## TrxAVR-Picastar by G3VPX.

## Errors on the PCB:-

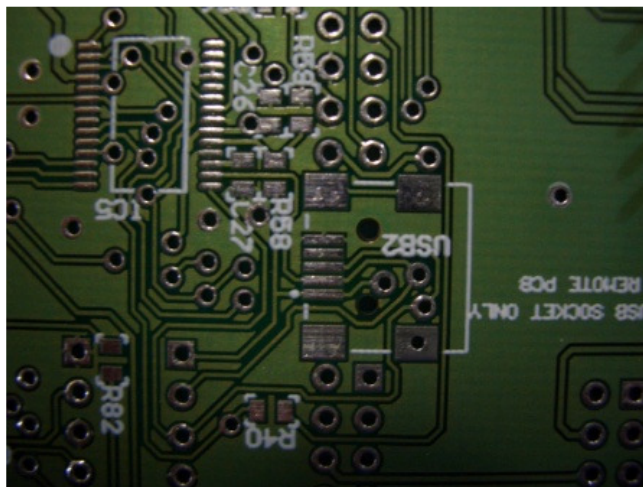
On the connector J6C on the bottom left of the PCB, the text "A0" & "RD" are reversed. You can scrape them off with a knife or use a marking pen to revise them. (not shown)

There is an error on the central "USB2" connector. This probably won't be a problem to most builders. There is no ground connected to the top pin. (the very centre of picture, just to right of "R58") This USB connector though is ONLY used if the central section of the PCB is removed, as per the information above. There is a ground hole just to the left side of C27 so a short near horizontal wire could be fitted. Normally, the other USB connector further to the right will be used, or a remote USB socket.

### The 8 button keypad (right hand small PCB on panel)

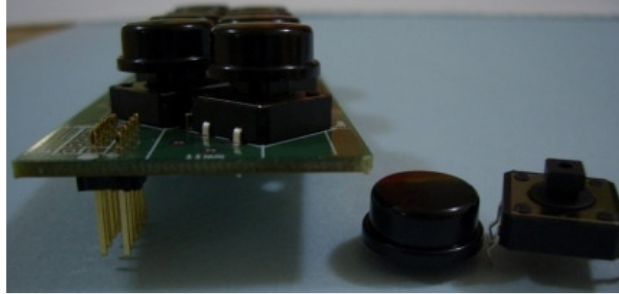
The holes for the 10 way IDC connector have been drilled 2mils (2 thousands of an inch) undersize. This does not sound like much but the connector will NOT go in. The best way to solve this problem is to use a sharp knife and scrape two corners of each pin of the connector a little, until it can be comfortably inserted into the PCB. Do NOT drill the PCB holes out as they are plated through holes and you will lose connectivity.
